International
Aero Engines

SERVICE BULLETIN

NACELLE – POWERPLANT - REPLACEMENT OF FIRE DETECTOR CLAMPS

V2500-NAC-26-0013

ROUTING OF THE CORE FIRE DETECTOR
FIGURE 1, SHEET 1 OF 4

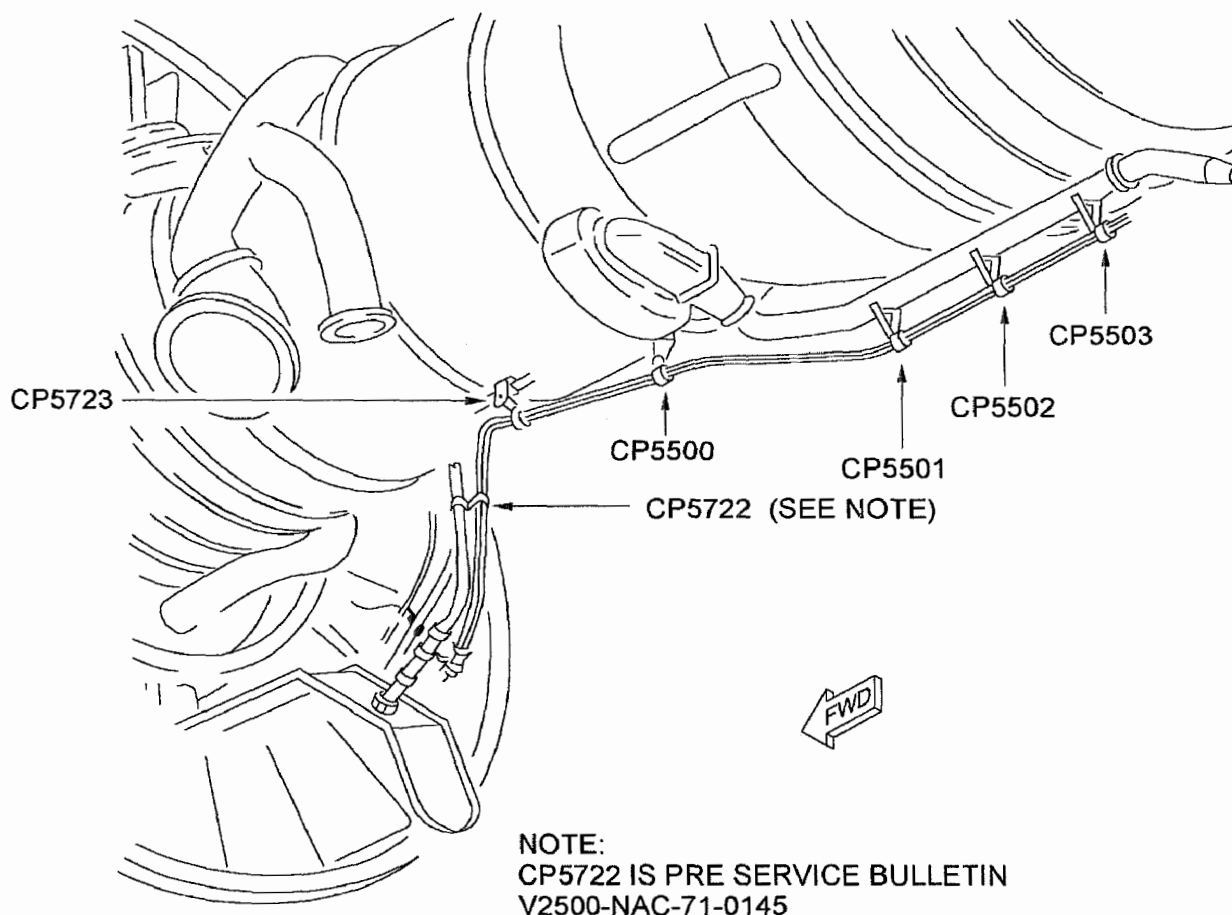
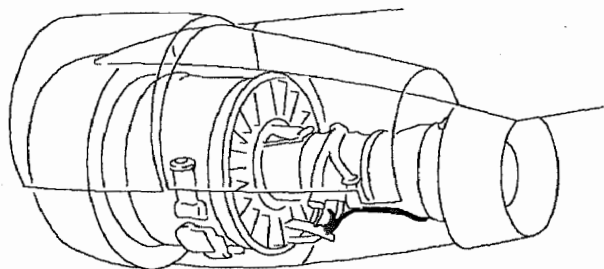
- (1) At Clipping Points CP5501, CP5502 and CP5503 install the C10GT3-08 Clamp Assembly to the Fire Detector and the 740-5035-501 Bracket with an AS21408 Bolt, an SP155-D Washer and an AS20624 Nut. Refer to Figure 1, sheet 1 and sheet 2.
- (2) At Clipping Point CP5500 install the C10GT3-08 Clamp Assembly to the Fire Detector and the 740-5034-503/505 Bracket with an AS21408 Bolt, an SP155-D Washer and AS20624 Nut.
- (3) At Clipping Point CP5723 install the C10GT3-08 Clamp Assembly to the Fire Detector and the 'J' Blade (attached to the JAEC Pipe) with a 4W0127 Bolt, the LK56556 and LK67295 Spacers, and a 4W0001 Nut. Refer to Figure 1, sheet 1 and sheet 3.
- (4) Torque the Nuts to 36 to 45 lbfin (4 to 5 Nm).

CLIPPING OF THE CORE FIRE DETECTOR
FIGURE 1, SHEET 4 OF 4

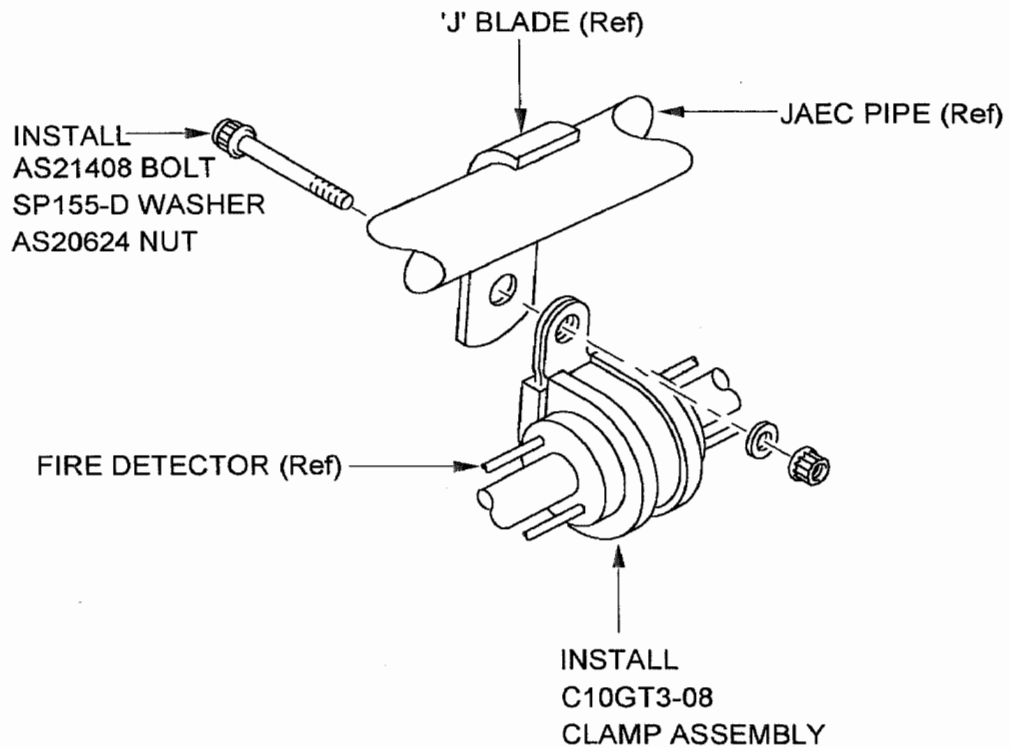
- (1) Do steps (1) thru (3) from Part A.
- (2) At Clipping Point CP5722 install the C10GT3-08 Clamp Assembly to the Fire Detector and the 'J' Blade (attached to the JAEC Pipe) with an AS21408 Bolt, an SP155-D Washer and an AS20624 Nut. Refer to Figure 1, sheet 1 and sheet 4.
- (3) Torque the Nut to 36 to 45 lbfin (4 to 5 Nm).
